**Case No. 14-1298-EL-REN  
Lambert Residential  
Staff Interrogatories – Initial Set**

Picture taken July 28, 2014 at 12:00pm – noon.

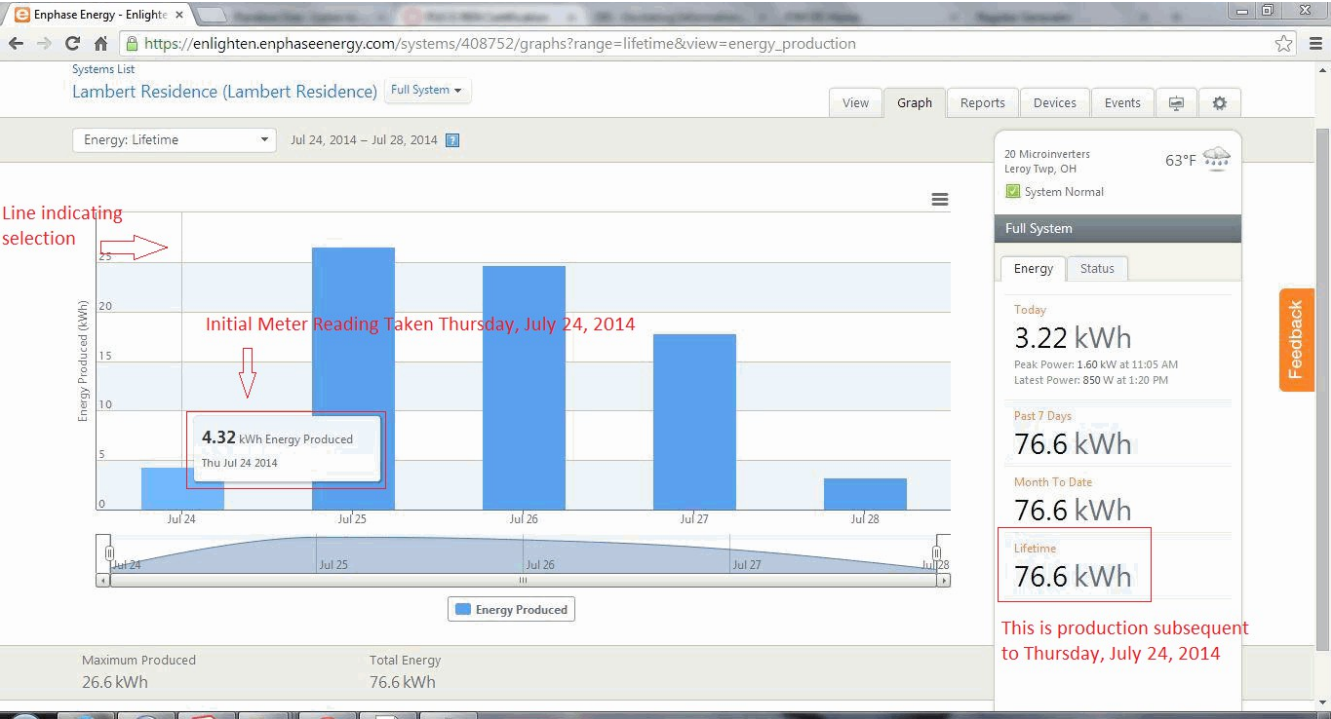
Question 3: In section N.1.e you state that that the meter reading is 4.32 kWh. But the enphase screen shot shows the meter reading as

Is the meter reading 76.6 kWh?

Answer 3: The initial meter reading was 4.32 kWh on July 24, 2014, the day the system went online. The production since that date had accumulated to 76.6kWh at the time of the picture (picture was taken July 28, 2014 @ 12:00pm noon). Please see picture below for clarification.
